Access Compliance Report

Public Rights-of-Way

Intersection ID: 14994	Main Street: OLD_MEADOW_RD	Cross Street: SHACKLEFORD_TR	Location: NE
ADA ID: BCB14E250876	Ramp Type: PerpDiag	Initial Pass/Fail: Fail	Overall Compliance: No
		Severity Score: 12.5

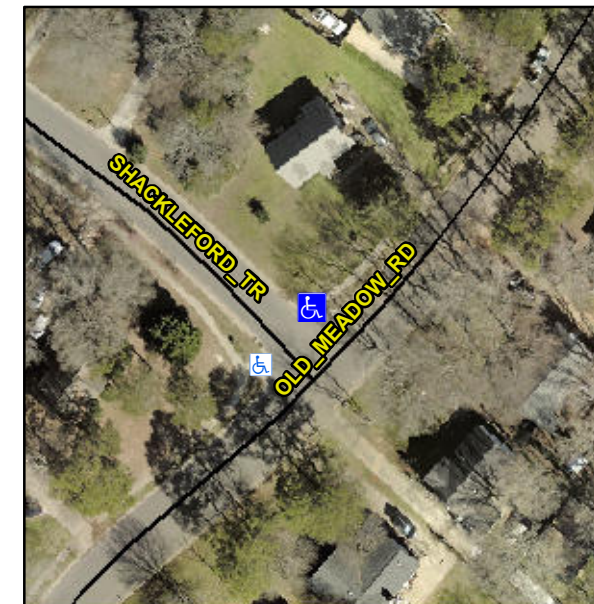
Not Found, R304.2.2

Compliance	Description	Data	Compliance	Description	Data
N/A	Ramp Length (in)	60.0	No	Ramp Slope (%)	8.7
Yes	Ramp Width (in)	48.0	Yes	Ramp XSlope (%)	1.3
N/A	Flare Type LT	N/A	N/A	Flare Type RT	N/A
N/A	Flare Slope LT (%)	N/A	N/A	Flare Slope RT (%)	N/A
N/A	Flare Traversable LT?	N/A	N/A	Flare Traversable RT?	N/A
N/A	Landing Length (in)	N/A	N/A	DWS Provided?	N/A
N/A	Landing Width (in)	N/A	N/A	DWS Contrast?	N/A
N/A	Landing Slope (%)	N/A	N/A	DWS Length (in)	N/A
N/A	Landing X Slope (%)	N/A	N/A	DWS Full Width?	N/A
N/A	Landing Curb? (Y/N)	N/A	N/A	DWS Offset (in)	N/A
N/A	Shared Landing?	N/A			
N/A	Gutter Ponding?	N/A	N/A	Gutter Slope (%)	N/A
N/A	Gutter Lip Ht (in)	N/A	N/A	Gutter X Slope (%)	N/A
N/A	Painted X Walk1?	No	N/A	Painted X Walk2?	No
	X Walk 1 Direction	To SW		X Walk 2 Direction	To SE
N/A	X Walk 1 Width (in)	N/A	N/A	X Walk 2 Width (in)	N/A
	X Walk 1 Slope (%)	4.5		X Walk 2 Slope (%)	4.2
	X Walk 1 X Slope (%)	2.2		X Walk 2 X Slope (%)	2.0

Remove & Replace Curb Ramp With Two New Directional Ramps or Equivalent.
